Addendum Number: 01

Addendum Issue Date: April 17, 2025

Project Name: Robinson Washington Elementary
Renovation & Addition

Project Number: 02401781.001

1 ENLARGED ROOF PLAN - AREA A
SCALE: 1/8" = 1'-0"

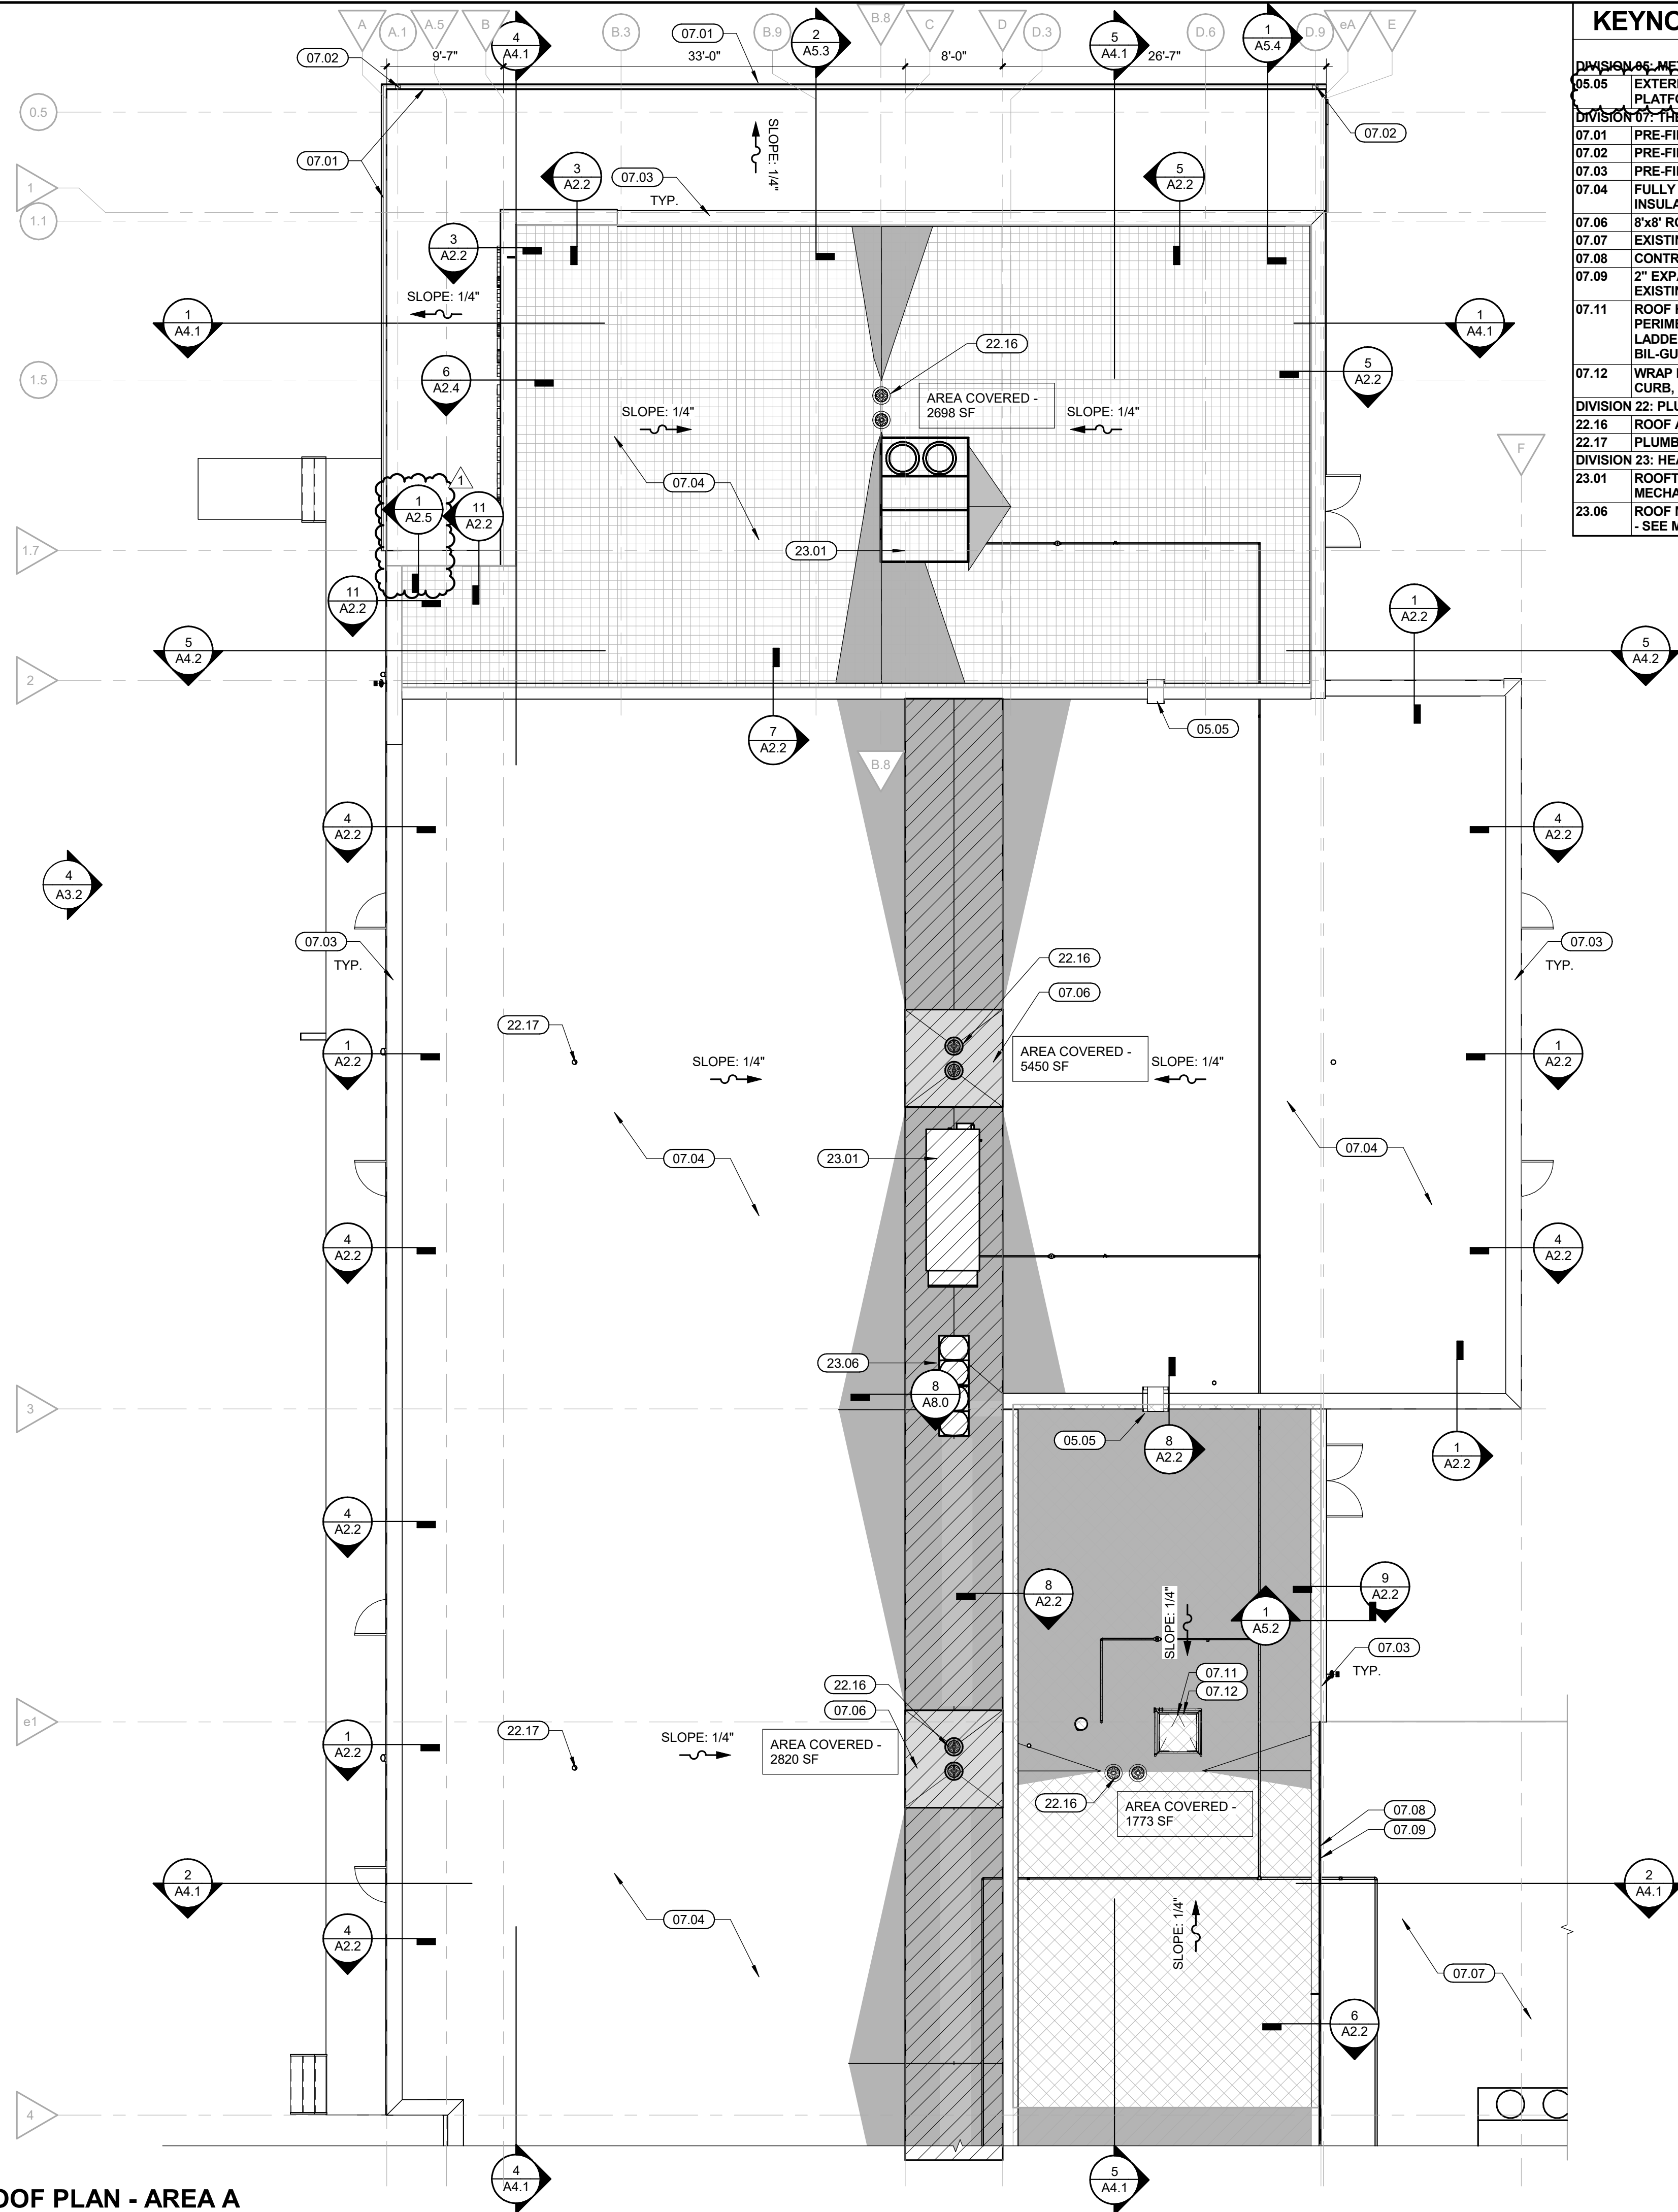
- a. REVISE keynote 05.05 to read, "EXTERIOR PRIMED 2'-0" STEEL ROOF ACCESS LADDER WITH PARAPET PLATFORM AND RETURN, PAINT." See attached.
- b. ADD section tag at north wall of vestibule 101A to indicate new canopy connection detail, 1/A2.5. See attached.

6 GROSS MOTOR AWP DETAIL AT GRADE
SCALE: 1 1/2" = 1'-0"

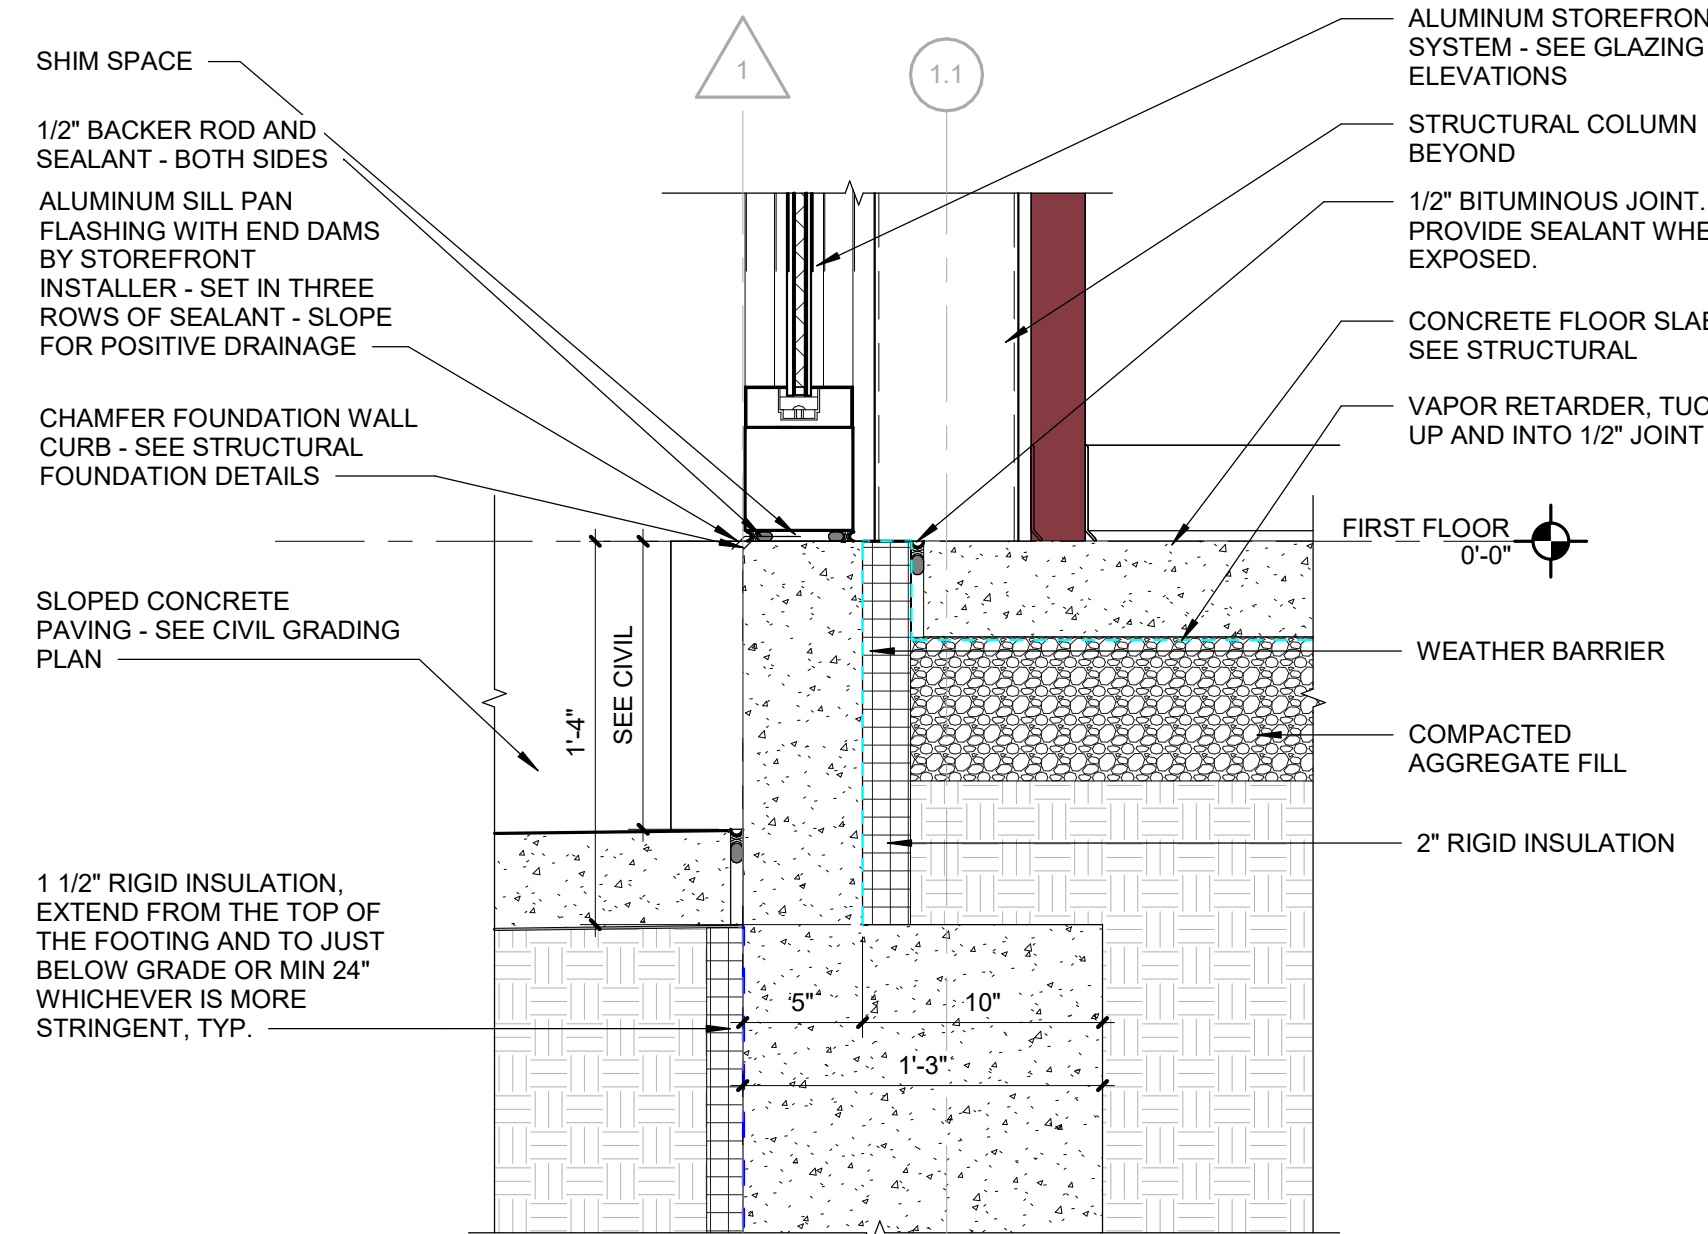
- 15. A5.9 – EXTERIOR DETAILS
 - a. REVISE annotation in Detail 6 to read, "5/8" AWP SYSTEM ON ½" EXTERIOR SHEATHING". See attached.
- 16. A7.2 – DOOR SCHEDULE, ELEVATIONS AND DETAILS

1 REFLECTED CEILING PLAN - AREA A
SCALE: 1/8" = 1'-0"

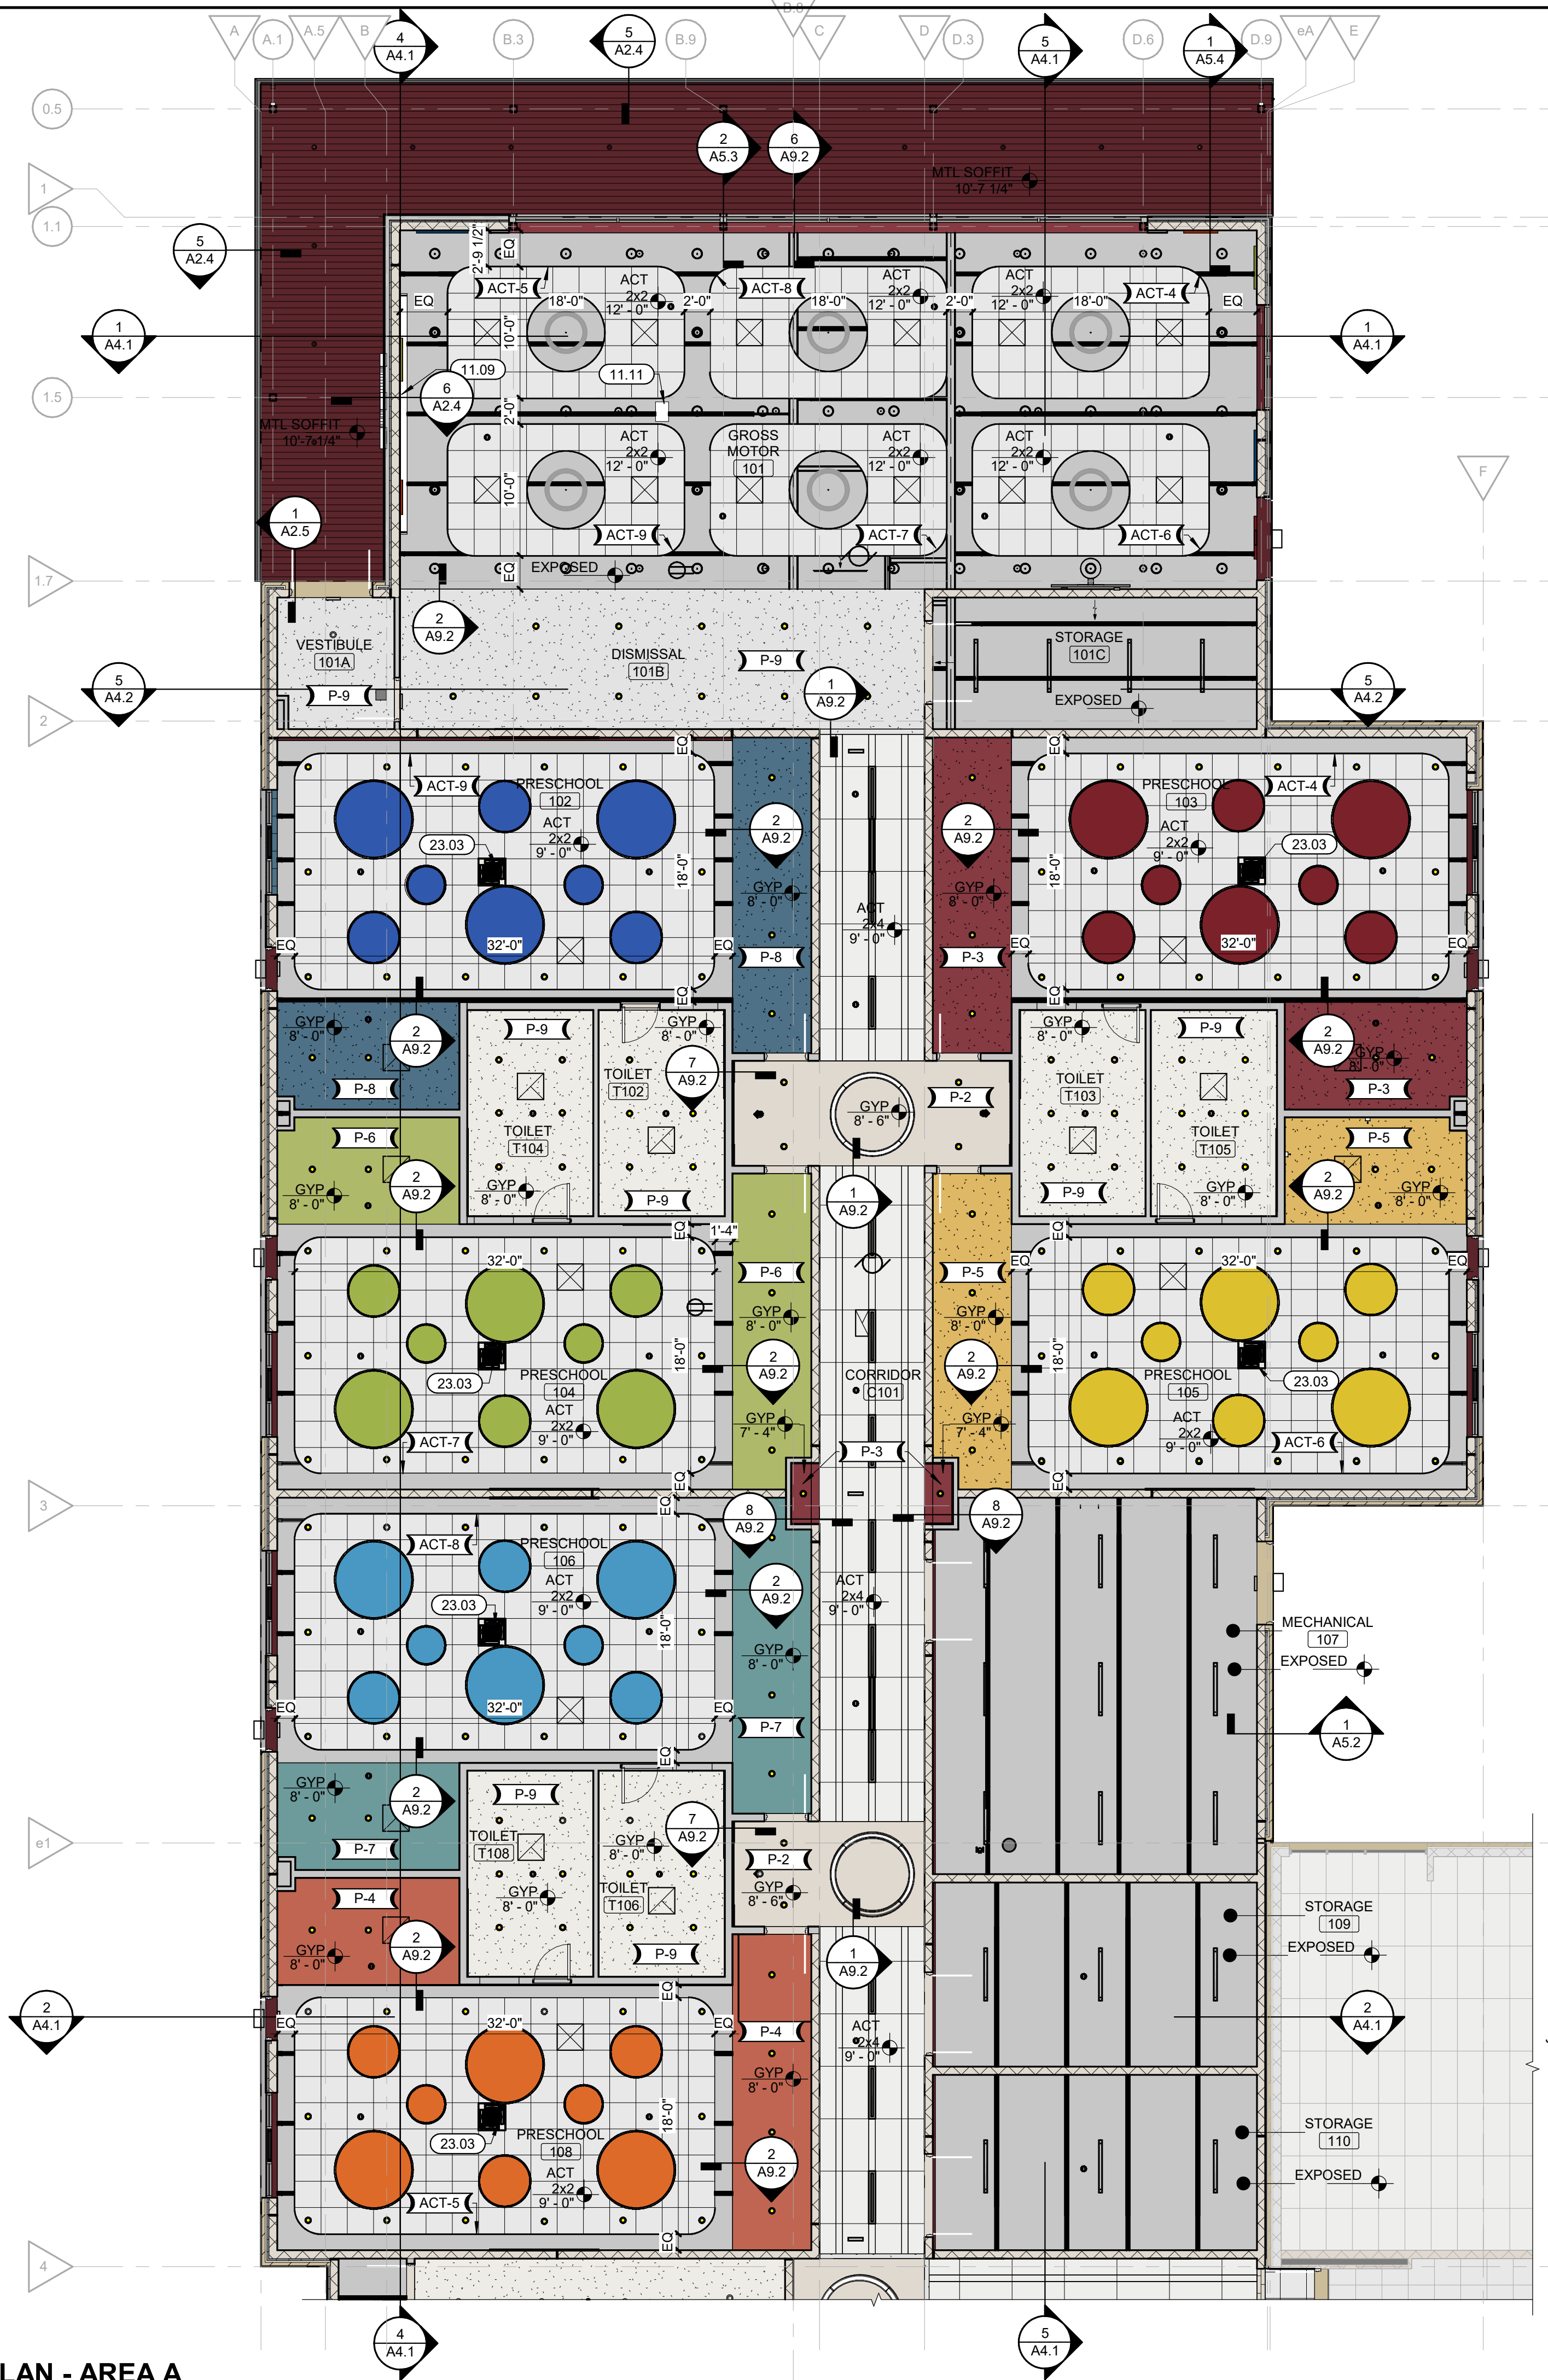
- a. ADD general note F to read, “ALL EXISTING CEILINGS SHALL REMAIN UNLESS OTHERWISE NOTED. PLEASE PROVIDE ADDITIONAL TILES, GRIDS OR OTHER ACCESSORIES AS REQUIRED IN ORDER TO PERFORM NECESSARY MECHANICAL INSTALLATION.” See attached.
